Product Update: Insight Rear Window Wiper Motor

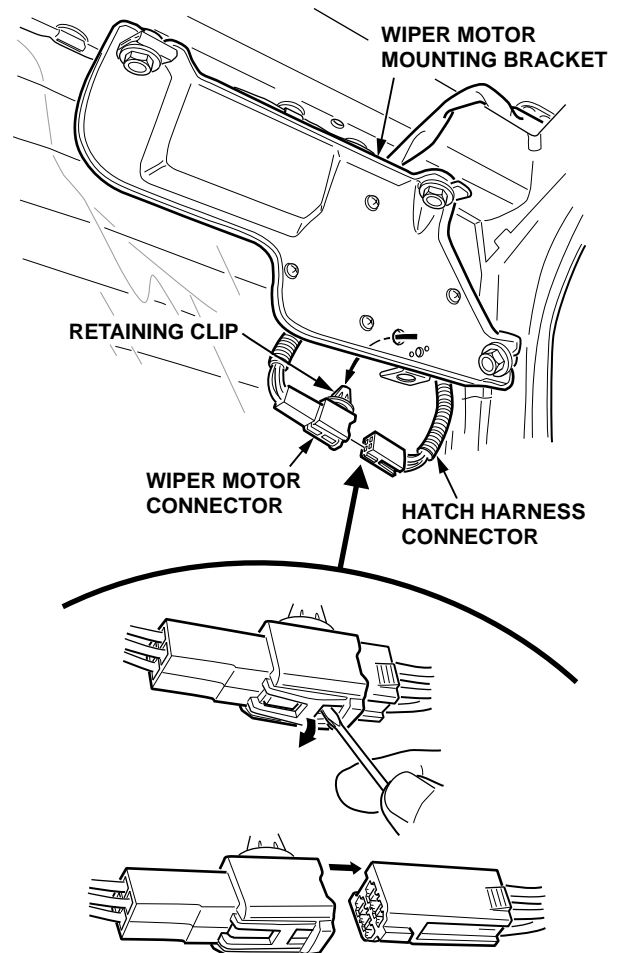
1. Open the rear hatch. Remove the two trim panel clips next to the striker.
2. Use a flat-tip screwdriver wrapped with tape or a cloth to remove the rear hatch trim panel.
3. Unclip the connector retaining clip from the wiper motor mounting bracket.

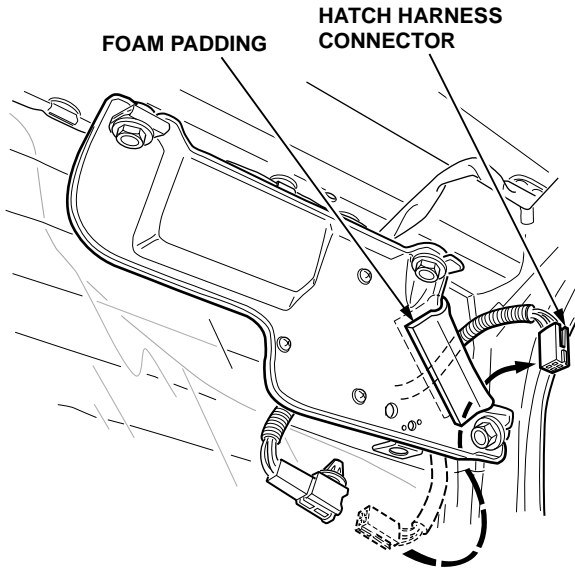
4. Disconnect the wiper motor connector from the hatch harness connector.

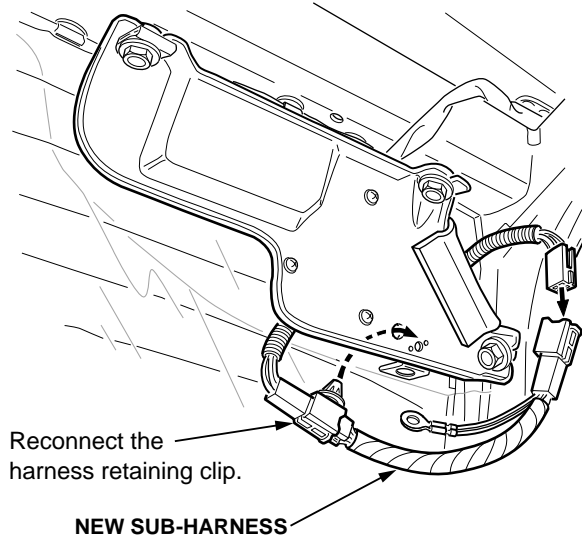
- Pull the hatch harness out through the opening between the hatch frame and the wiper motor mounting bracket.

- Apply a piece of self-adhesive foam padding from the kit to the edge of the motor mounting bracket.
- Connect the sub-harness from the kit to the wiper motor connector.
- Reinstall the wiper motor connector retaining clip in the motor mounting bracket.

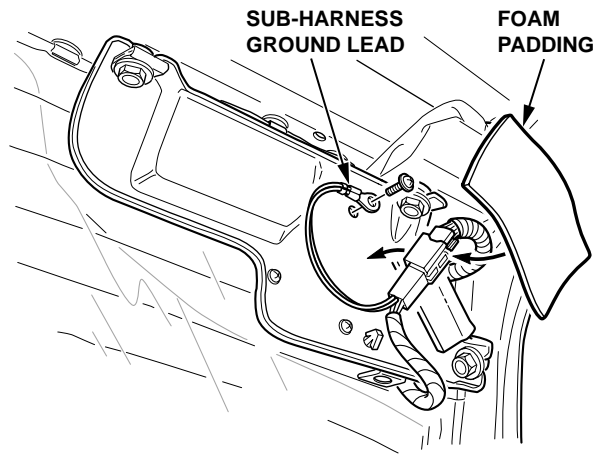
- Route the sub-harness around the motor mounting bracket, then connect it to the hatch harness.

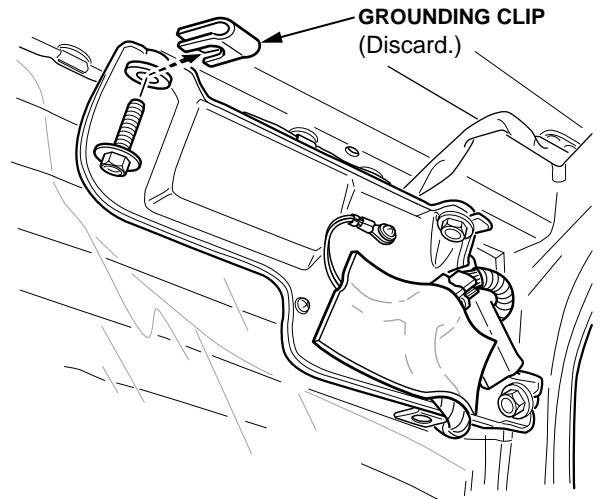
- Attach the sub-harness ground lead to the motor mounting bracket.

- Cover the sub-harness with the self-adhesive foam padding from the kit.
- Remove the grounding clip from the wiper motor bracket mount. Torque the bolt to 9.8 N-m (7.2 lb-ft).
